TECHNICAL INSTRUCTION HAC25-001, Rev. NC, March 24, 2025

INSTRUCTIONS FOR CONTINUED AIRWORTHINESS

a) 34265-8FS: Cockpit Light

INSTALLED ON
BOEING 737, 747, 757, and 767 SERIES AIRCRAFT
(SEE FSCC SUPPLEMENT(s) FOR SPECIFIC MODELS)

3. Flight Kit/Reading Light - Lamp Replacement
(Figure 202)

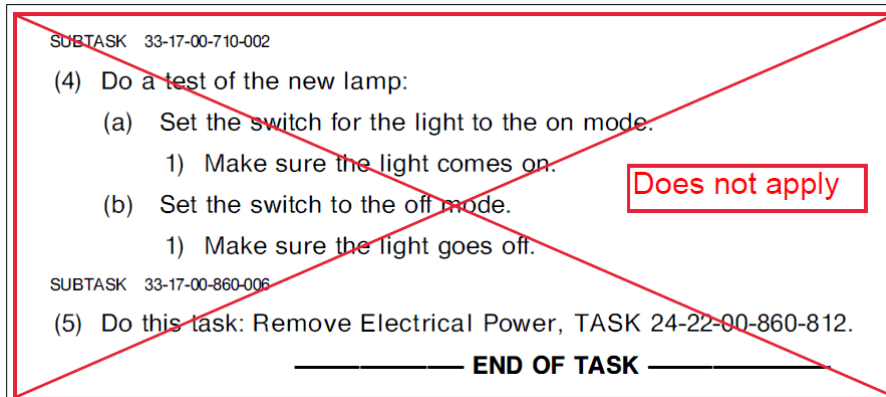
- (1) Map light - Lamp Replacement
- ~~(2) Flight Kit/Reading Light - Lamp Replacement~~
- (3) Chart Light - Lamp Replacement

- (a) Remove the retainer [23].
- (b) Remove the lens [22].
- (c) Replace the lamp [21].
- (d) Install the lens [22].
- (e) Install the retainer [23].

Does not apply

- Boeing AMM 33-17-00, page 205 dated Oct 15/2013:

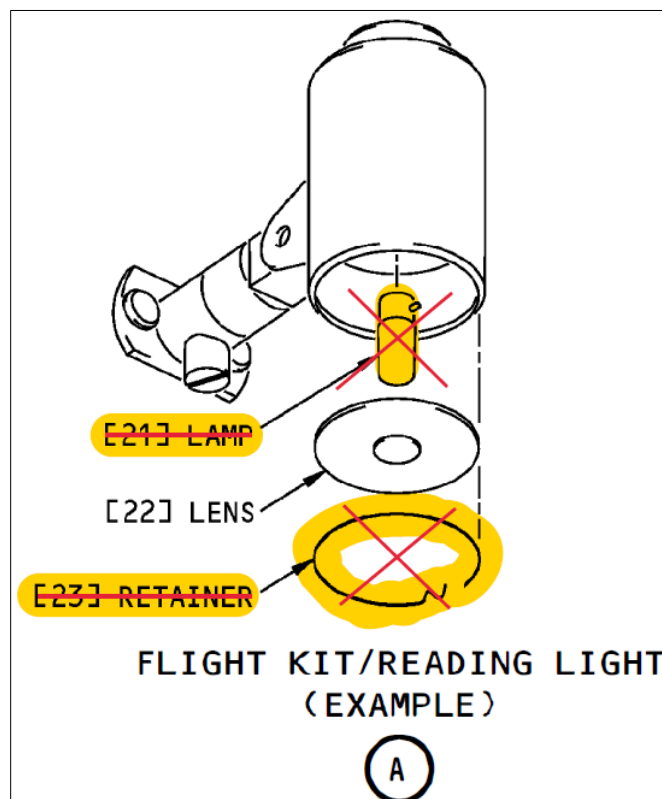
- Boeing AMM 33-17-00, page 205 dated Oct 15/2013:

5. Flight Kit/Reading Light - Lamp Replacement
(Figure 205) Does not apply

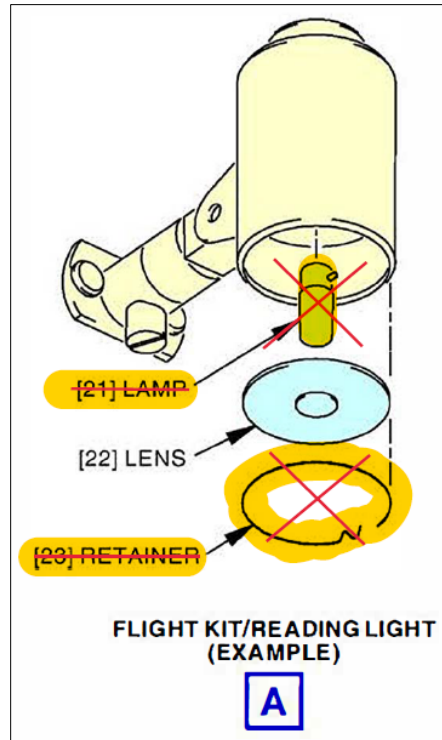
- Remove the retainer [23].
- Remove the lens [22].
- Replace the lamp [21].
- Install the lens [22].
- Install the retainer [23].
